Contents

Description: Brake Line Unions to ABS Modulator

Models affected: Tiger 800 and Tiger 800XC

Item 1.

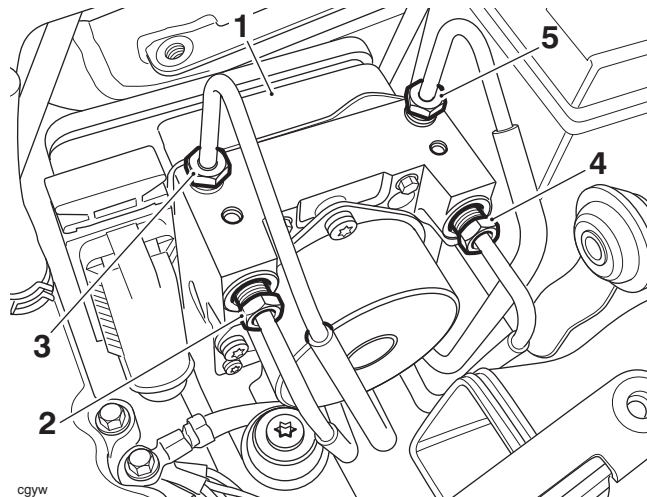
The torque figure for the brake line unions to the ABS modulator has changed to **15 Nm** on the above models.

- **Models already in service need not be re-tightened unless the fixings have been loosened or removed.**

Item 2.

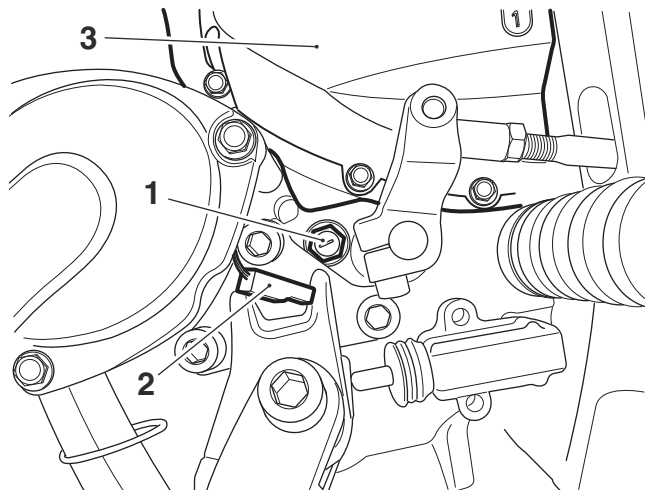
If for any reason the neutral light switch requires replacing on the above models from VIN 596697, a parts kit containing a neutral light switch and a 1.5 mm washer is available. For models up to VIN 596696 refer to Technical News 148, dated August 2013. When ordering replacement parts, always refer to the EPC.

- Parts kit T1190904 is for use when the neutral light switch is replaced on motorcycles from VIN 596697.

Item 4.

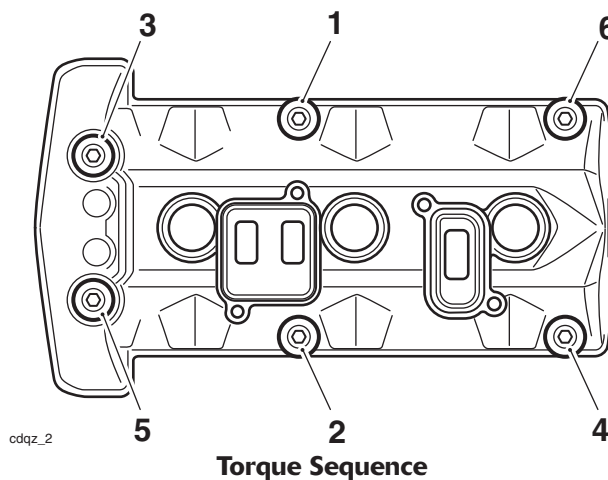
The torque figure for the camshaft cover fixings has changed to **10 Nm** on the above models.

- **Models already in service need not be re-tightened unless the fixings have been loosened or removed.**

Item 5.

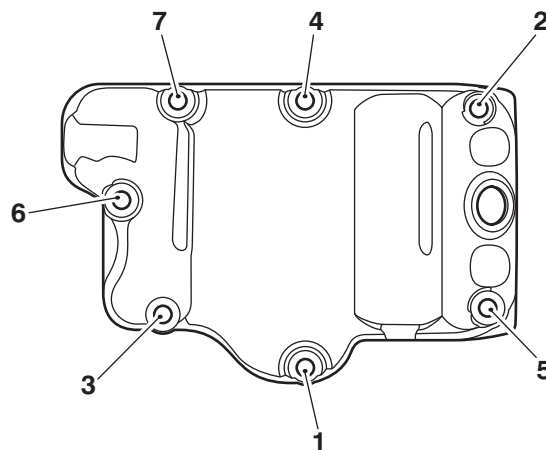
The fixings securing the breather cover to the crankcase are pre-encapsulated on the above models and therefore must be replaced if removed for any reason. The **11 Nm** torque figure remains unchanged.

Item 6.

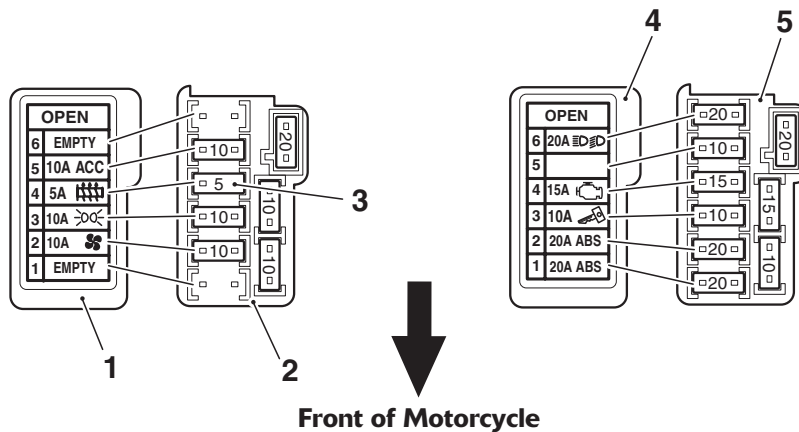
The heated grips fuse rating has changed to 5 Amps on the above model from VIN 632831.

Item 7.

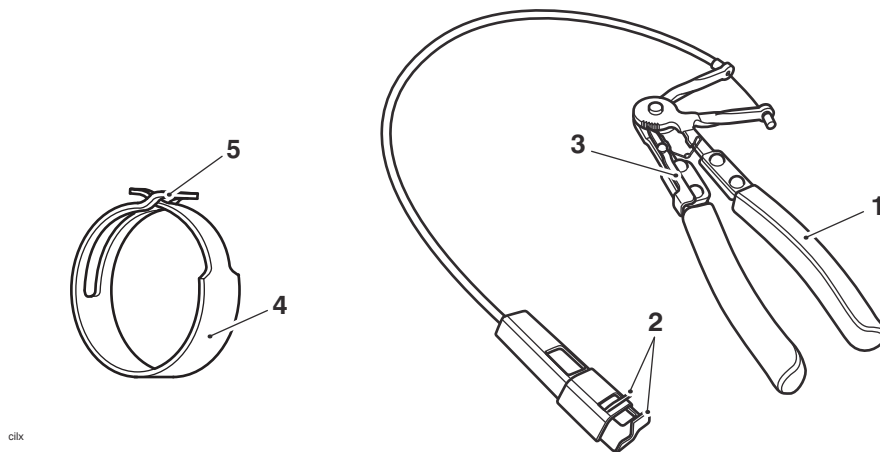
Triumph has introduced constant tension coolant hose clamps to all water cooled models currently in production from November 2013. The constant tension clamps have been introduced to each model at various VINs and will replace all existing screw type coolant hose clamps.

Screw type hose clamps fitted to models prior to this change must NOT be replaced with constant tension hose clamps. When replacing coolant hose clamps, always replace with clamps of the same size and type. Failure to replace the clamps on a like for like basis may result in a coolant leak. Loss of coolant may cause the engine to overheat and suffer severe damage.

Service tool T3880207 has been released for use with the constant tension hose clamps.
